County of Albemarle
COMMUNITY DEVELOPMENT/PLANNING

TO: Architectural Review Board
FROM: Mariah Gleason, Senior Planner II
RE: SDP-2023-71: Old Ivy Residences (final site plan) – level of ongoing review by ARB
DATE: January 10, 2024

Figure 1: Staff determination on areas of the Old Ivy Residences site that will be visible from the EC.

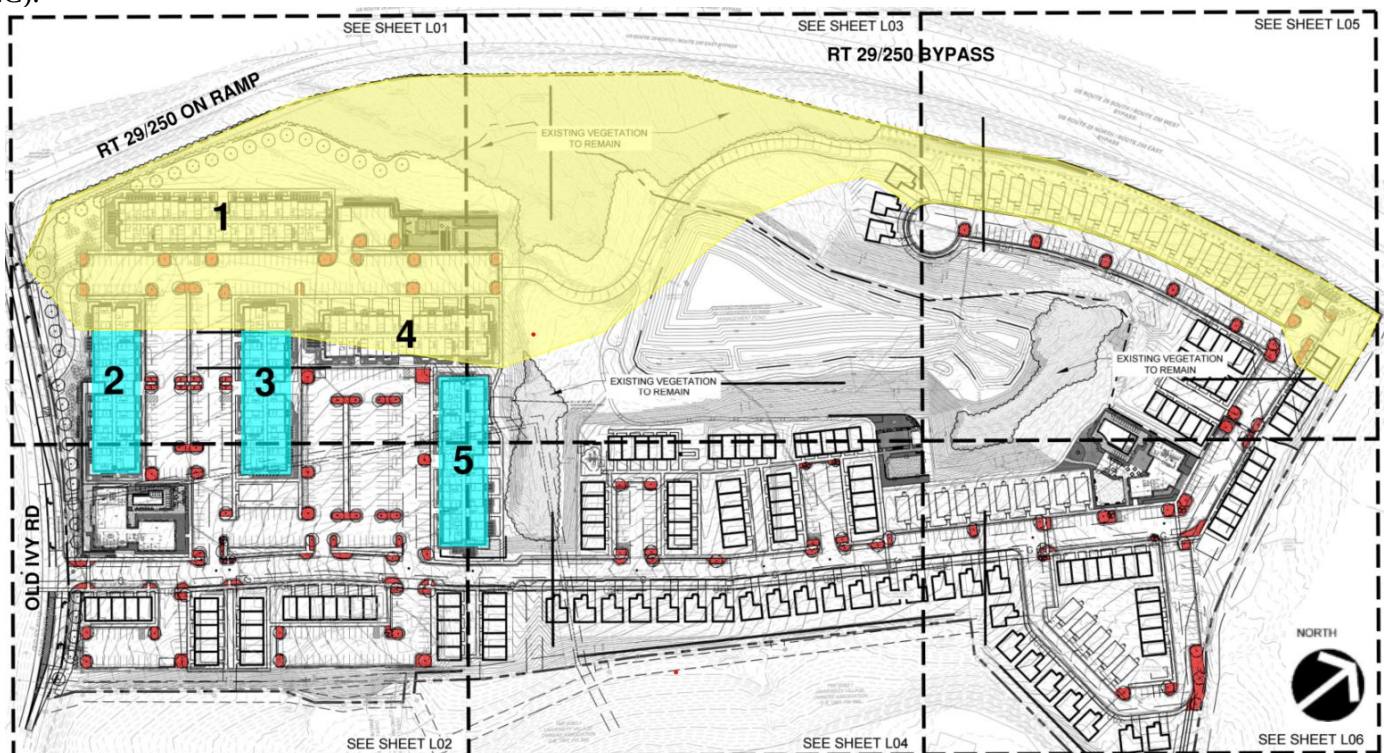
1. **Apartment Building 1** - a 4/5-story split apartment building
 - a. A 12-foot buffer of existing vegetation is proposed to remain along the on-ramp, west of this building. A row of large canopy trees is proposed on the development side of that buffer. This vegetation will filter views of the building. The building elevations do not exhibit excessive blankness or a “back of building” appearance, so full screening is not needed. The building will be visible, so ARB review is required.

2. **Portions of Apartment Buildings 2 and 3** – 4-story apartment buildings
 - a. A 15-25-foot buffer of existing vegetation is proposed to remain at the entrance to the Rt. 29/250 on-ramp, at the southwestern property corner. Large canopy trees are proposed along Old Ivy Rd., south of Building 2. (Some are shown within the existing vegetation area.) This vegetation will help filter views of these buildings. Sheet 3 of the Perspectives and Site Sections document (Attachment 4) confirms that portions of the buildings will be visible from the EC. The buildings do not exhibit excessive blankness or a “back of building” appearance, so full screening is not needed. Portions of the buildings that will be visible from the EC will require ARB review.

3. **North and West Elevations of Apartment Building 4** – a 4/5-story split apartment building
 - a. Apartment Building 4 is separated from the EC by approximately 300 feet of existing vegetation that will be preserved; however, the preserved areas are lower in elevation than the EC and proposed buildings. During winter months particularly, it is anticipated that the north and west building elevations will be visible from the EC. (See pages 18 and 19 of Attachment 5.) These building elevations do not exhibit excessive blankness or a “back of building” appearance, so full screening is not needed. However, since these building elevations will be visible from the EC, ARB review is required.

4. **Portions of Parking Areas between Apartment Buildings 1, 2, and 3 and west of Apartment Building 4**
 - a. Existing vegetation is being preserved along the EC frontage. However, topography is such that portions of these parking areas will be visible from the EC, through the vegetation along the frontage. The EC guidelines for parking areas should be met in these areas to promote a coordinated and attractive appearance along the corridor.

5. **Dumpster Enclosure north of Apartment Building 1 and west of Apartment Building 4**
 - a. The topography of the site will allow the dumpster to be visible from the EC. It will appear perched above stacked retaining walls located just west of the dumpster. Although shrubs are shown at the base of the lower retaining wall, these plants are unlikely to screen the dumpster from view of the EC. A dumpster screening detail is proposed. It will be subject to ARB approval.

6. **Recreation Area west of Apartment Building 4**
 - a. Topography and the location of stacked retaining walls will make the recreation area west of Apartment Building 4 visible from the EC, thus requiring ARB review. The landscape plan shows several features located within the recreation area although none are labeled so it is unclear what recreation activities are proposed. Provide complete details, notes, and labels for the proposed recreation area.

7. **Emergency Access Road**
 - a. The emergency access road is separated from the EC frontage by a proposed buffer of existing vegetation ranging from approximately 30-280 feet in width. The road will be visible from the EC because the buffer is lower than the access road and EC. Given this visibility, landscaping along the emergency access road should be consistent with EC guidelines for internal roads in areas where the existing tree buffer is located more than 10 feet from the road.

- a. Given topography and proposed building heights, noted as a maximum of 51'8" on the site plan, the upper stories of these buildings are expected to be visible from the EC. The building elevations visible from the EC do not exhibit excessive blankness or a "back of building" appearance, so full screening is not needed. The building will be visible, so ARB review is required.

1. Apartment Building 1 requires ARB review.
2. Portions of Apartment Buildings 2 and 3, identified in yellow in Figure 1, require ARB review.
3. North and west building elevations of Apartment Building 4 require ARB review.
4. The EC guidelines should be met for the portions of parking areas between Apartment Buildings 1, 2, and 3 and west of Apartment Building 4 that will be visible from the EC to promote a coordinated and attractive appearance along the corridor.
5. The dumpster enclosure north of Apartment Building 1 and west of Apartment Building 4 requires ARB review.
6. Provide complete details, notes, and labels for the proposed recreation area west of Apartment Building 4.

10. The upper stories of Apartment Buildings 2, 3, and 5, identified in blue in Figure 1, require ARB review.
